LOST CREEK ISR, LLC

**Re: Lost Creek Project Responses to Health Physics Comments
Docket No. 40-9068
TAC No. LU0142**

NRC and Lost Creek ISR, LLC's Detailed Discussion Summary

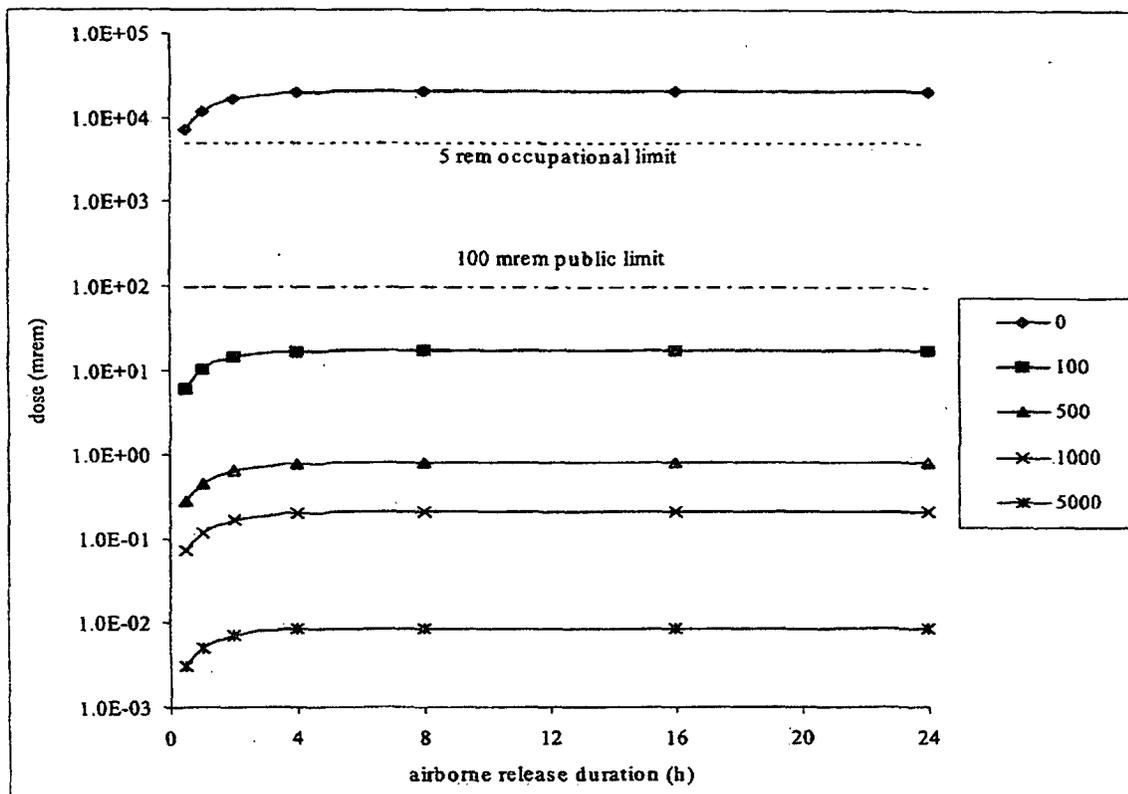
NRC staff disagreed with characterizing U_3O_8 and uranyl peroxide as interchangeable compounds. NRC staff stated that it is looking to see how substituting uranyl peroxide affects the accident scenario. This is necessary because U_3O_8 and uranyl peroxide have different chemical and physical properties that may impact the dose calculations.

NUREG CR-6733 Figure 4.2, reproduced below, indicates all doses to members of the public are well below any applicable standards, and would be further reduced to about 1 mrem / year if just solubility alone were considered and less if other factors presented in Table 1 were taken into account.

With regard to potential on-site (occupational) doses, the analysis in NUREG/CR-6733 for an accident involving thickener failure shows a potential dose at the center of the spill, to someone standing in the spill for four hours after the spill had dried, could exceed 5 rem. The assumption is that the spill consists of insoluble Class Y U_3O_8 . Reducing the dose estimate based on solubility considerations alone (ratio of DACs - see Table 1) results in a worker dose projection of about 500 mrem, not taking into account other credible emergency response mitigating actions as presented in Table 1. On page 4-22 of NUREG /CR-6733 it is stated that, "It is reasonable to assume that cleanup personnel would be outfitted with protective equipment including respirators." It is also likely that any spill would be cleaned up before it dried. The implication is that the dose is minimal while the spill is wet. Maintaining the spill "wet" during cleanup is an expected method of collection which will ensure dust control and minimize exposure potential. Air sampling during the cleanup process will provide a record of actual exposure.

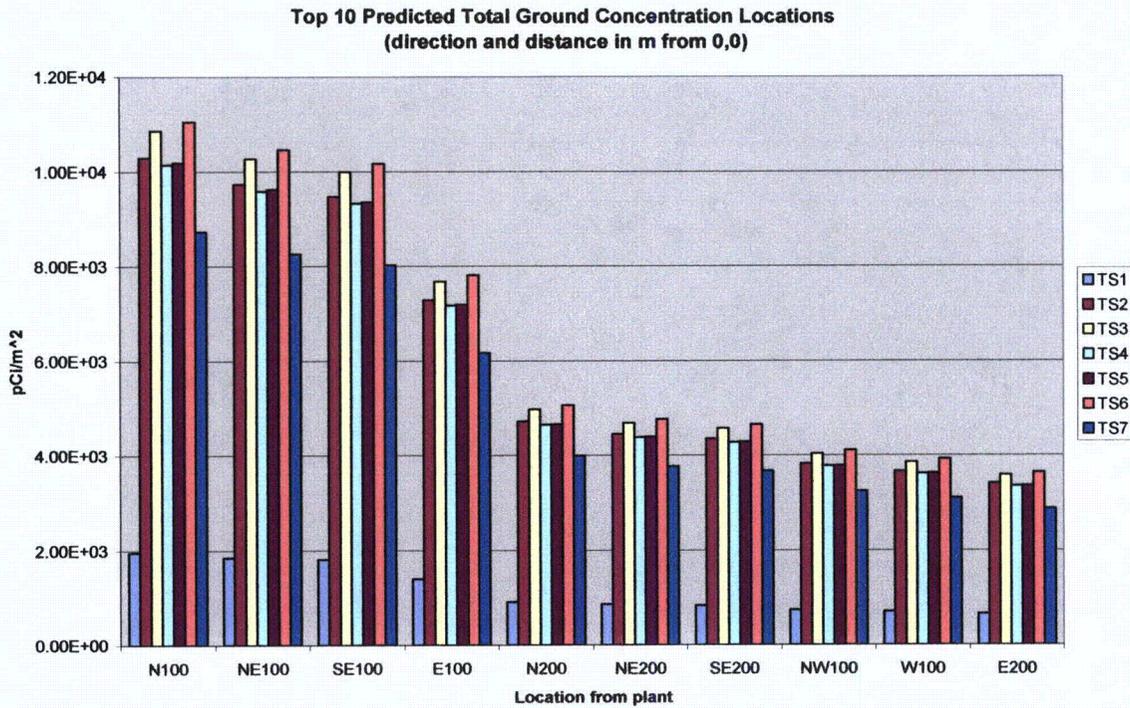
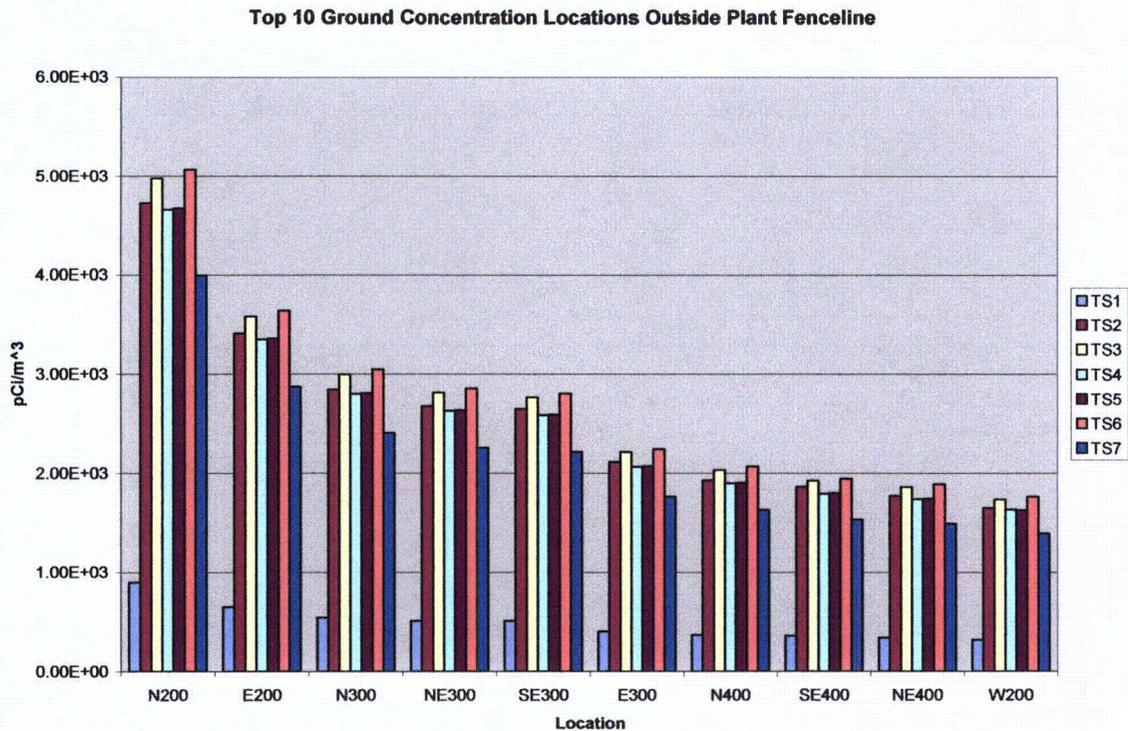
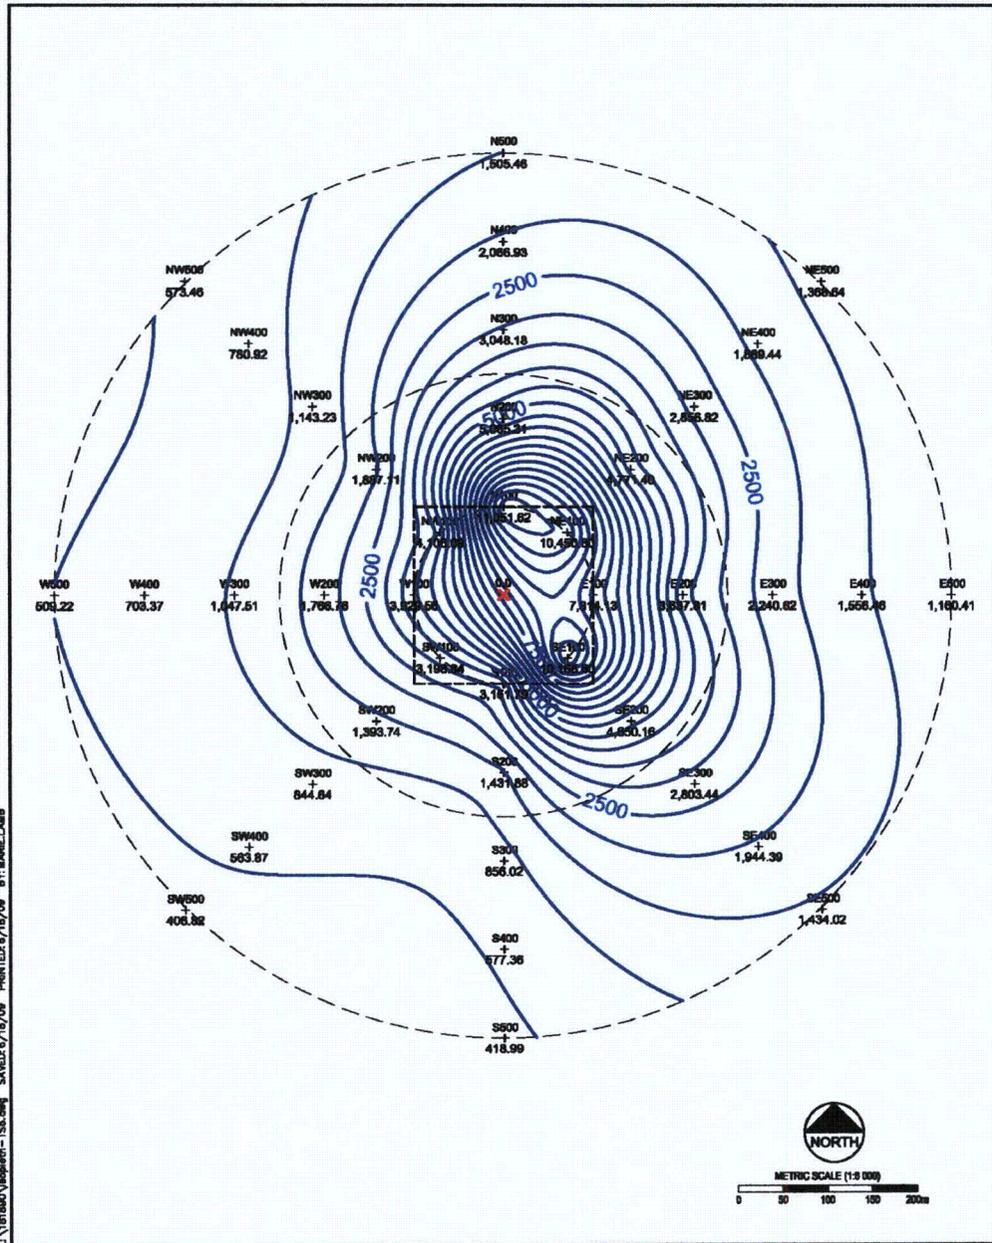
1) LCI does not address radon daughter deposition on vegetation as indicated in its application and this RAI question 2.9(3). The vegetation sampling data submitted was intended to address a future yellowcake dryer only. These locations would not necessarily be the same as areas maximally impacted by radon daughter deposition. As an example, NRC staff discussed the lack of sampling at the general locations near SEB1 and SEB2, which are the highest dose locations according to the modeling performed by LCI.

A series of 40 receptors was created in each of 8 compass directions in 100 m increments out to 500 m as shown below. The release point for the plant is point 0,0. Receptor locations were given names with the direction and distance from the origin. Receptor N100 is north of the plant center 100 m. Likewise, SE400 is 400 m southeast of the plant center. The approximate location of the plant fence line is shown for reference.

Results of the 40 radial receptors were compiled using total ground concentrations for the current time step (1 yr). Total concentrations include concentrations of Po-218, Pb-214, Bi-214 and Pb-210. Results of the top ten receptor locations for each time step are shown below.

The four highest (and 8 of the top 10) predicted ground concentrations in each time step are within the approximate plant boundary. The remaining two, N200 and E200 are approximately on the plant fence-line. Removing the locations that are closer than 200 m yields the following results.

The maximum value of 5,000 pCi/m² is shown at location N200, which is 200 m straight north of the plant center. Assuming that all activity resides in the top 1 cm of soil which has a density of 1.2 g/cm³, this equates to approximately 0.4 pCi/g of soil. Over the course of a year, it is unlikely that such low concentrations would be detected in soil or vegetation sample.

FIGURE 2.5-5
PASSIVE RADIOLOGICAL
SAMPLING LOCATIONS

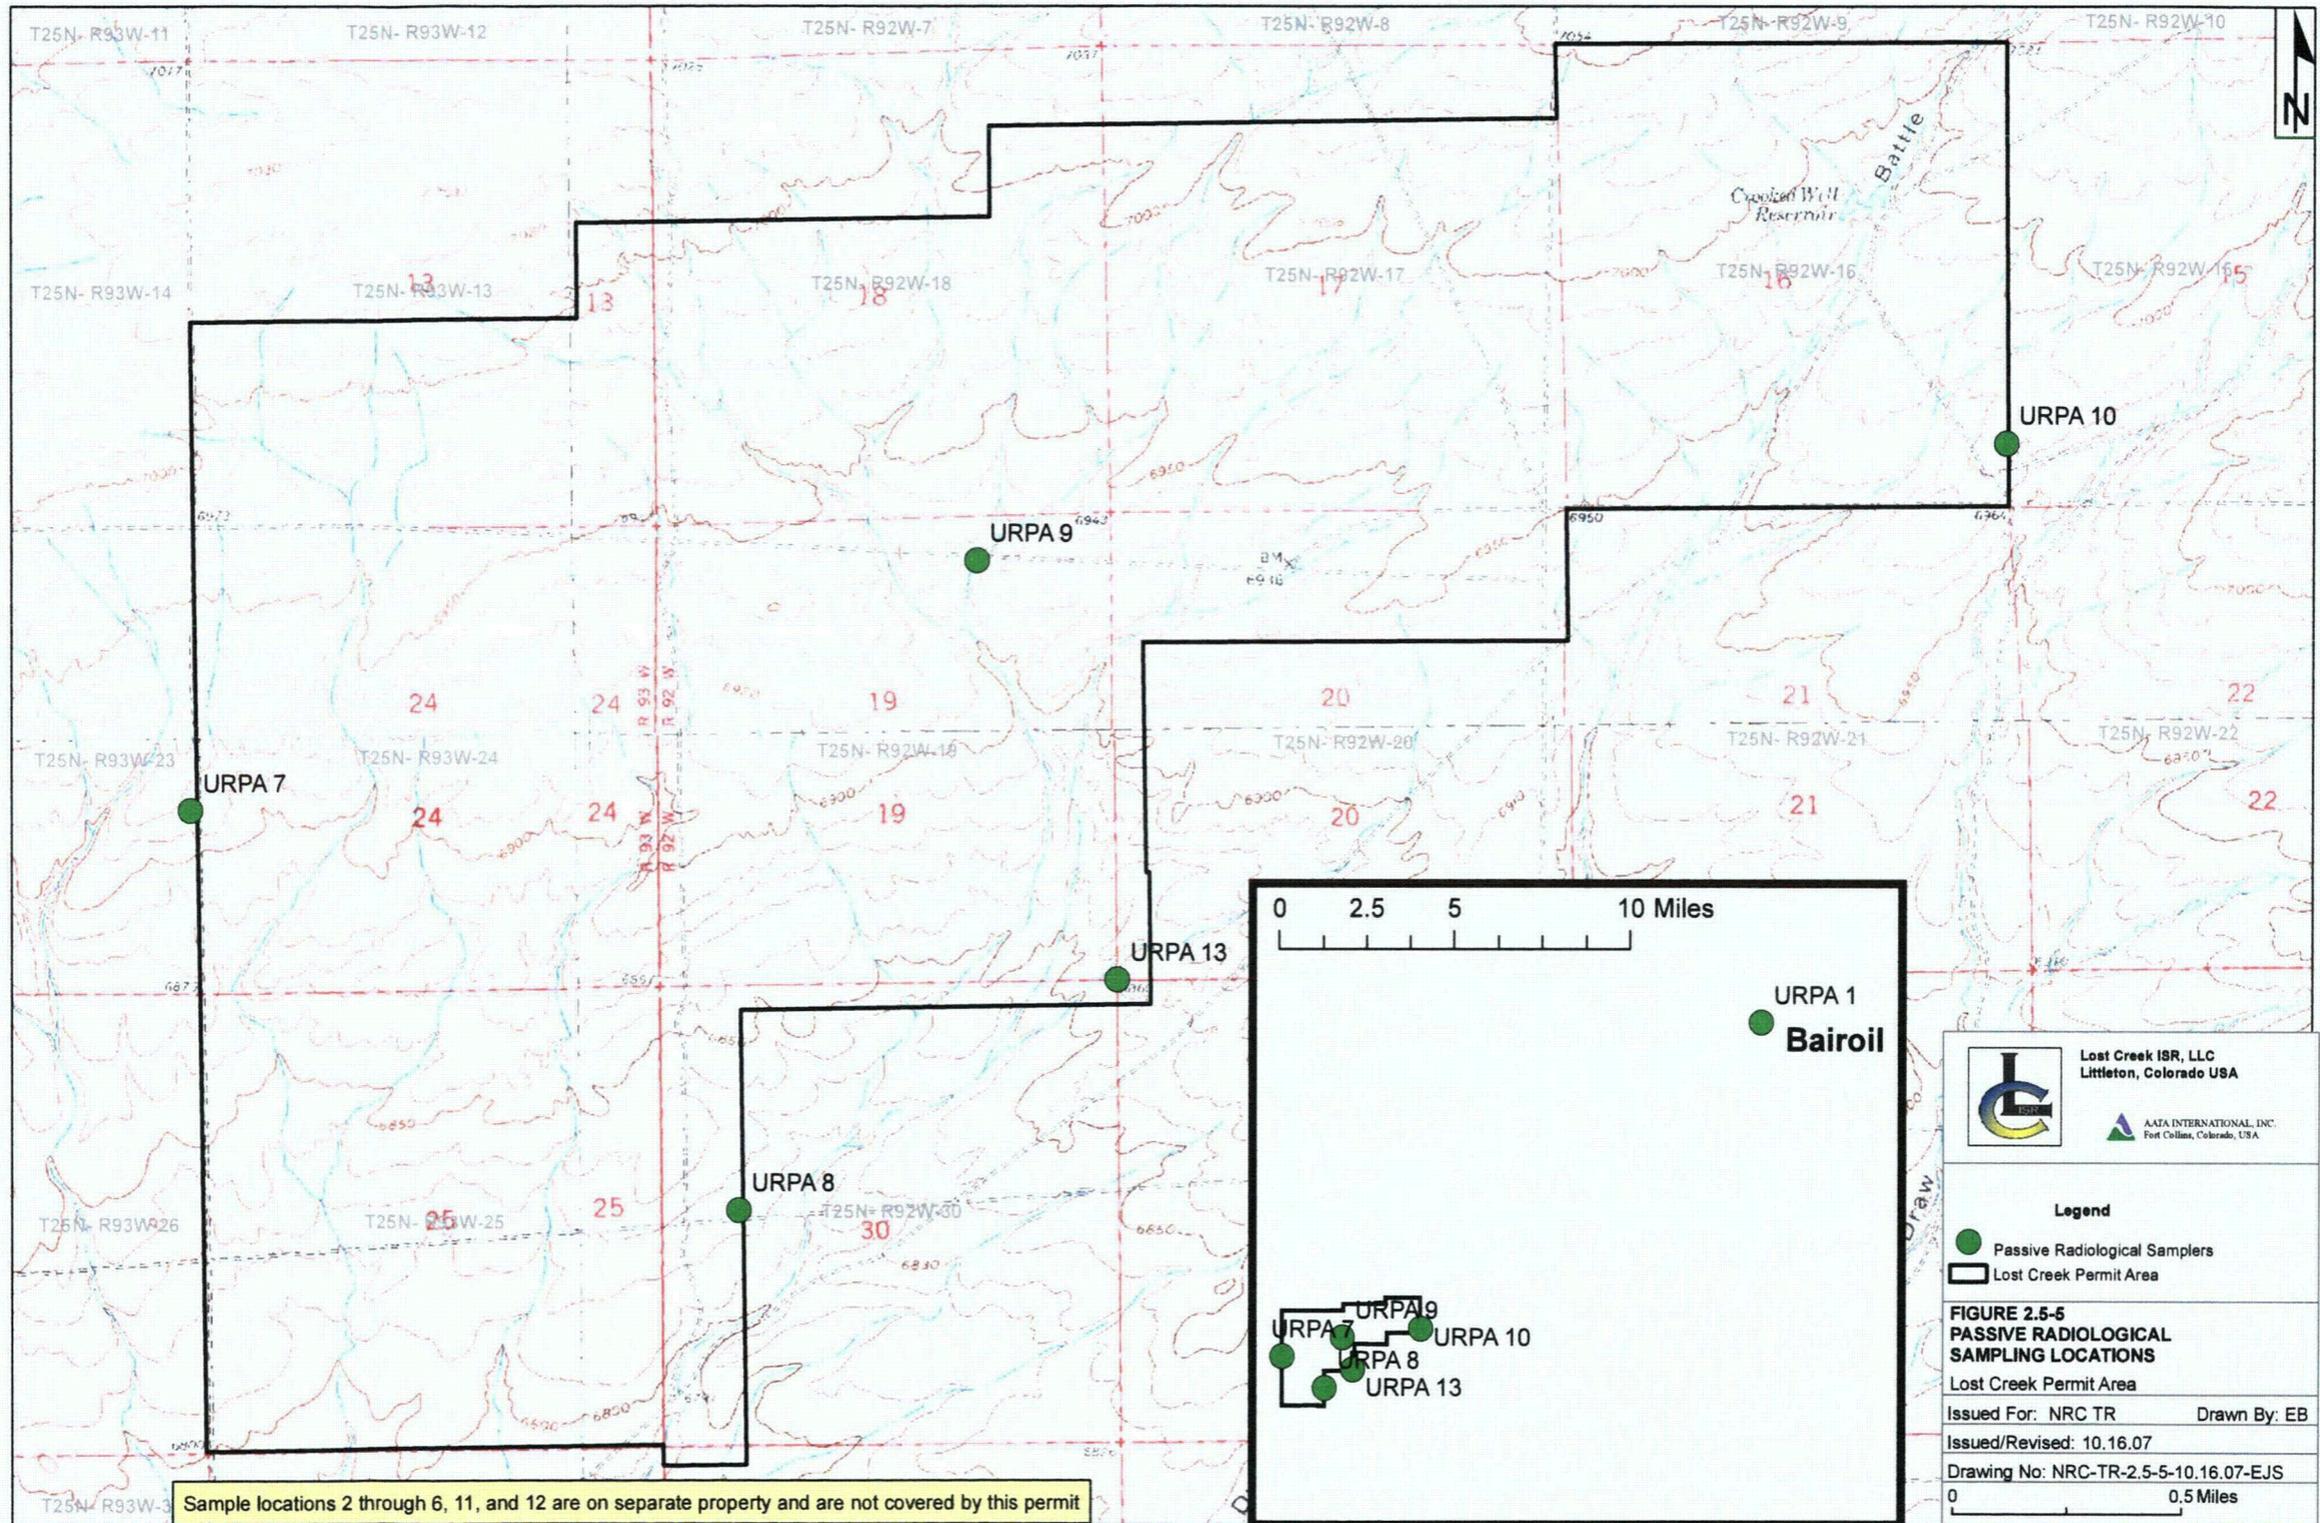
5) LCI does not address soil sampling, as recommended in RG 4.14 for an operational radiological monitoring program, and as asked RAI question 5.7.7(2). As pointed out in the question, and identified in the application, radon daughters will accumulate in soil, among other places. RG 4.14 includes Pb-210, a radon daughter, as a radionuclide to sample.

Co-Located Samples. Radon and gamma passive samplers were installed beginning in November 2006 (Attachment 3). At that time, the Plant Site had not been determined. Sampling locations were selected to represent: the center of the Permit Area (URPA-9); the upwind (URPA-7) and downwind (URPA-10) locations (based on site knowledge and available meteorological data); the southern Project Area boundary (URPA-8), which is closest to the Sweetwater Mill; and the closest residence (URPA-1). In February 2007, an additional sampling location (URPA-13) was added in response to the expansion of the proposed Permit Area.

The URPA-10 radon and gamma passive sampler site is co-located with the HV-4 air particulate sampling site, and the URPA-1 site is co-located with the HV-1 site. When reasonable estimates for the Plant Site location and predicted elevated radionuclide concentrations became available, it was determined that the best course of action was to select air particulate sampling locations independent of the passive samplers, in most cases, to provide more coverage of the site but still have some overlap.

In agreement with RG 4.14, LCI will monitor radon gas and direct radiation, at the same locations as in the preoperational monitoring (Attachment 3) plus at those additional operational locations described in LCI TR Section 5.7.7 (Attachment 4). Additionally, radon gas and direct radiation measurement will also be co-located with the background HV-3 particulate air monitor, and monitors HV-2 and HV-5 (Attachment 2). HV-2 is currently located within the location of the plant, so practically it must be relocated slightly and will be repositioned just outside the fence line nearest the MILDOS maximum point discussed above. There will then be a total of eleven locations with radon gas and direct radiation measurement; five of which will be co-located with the particulate air monitors.
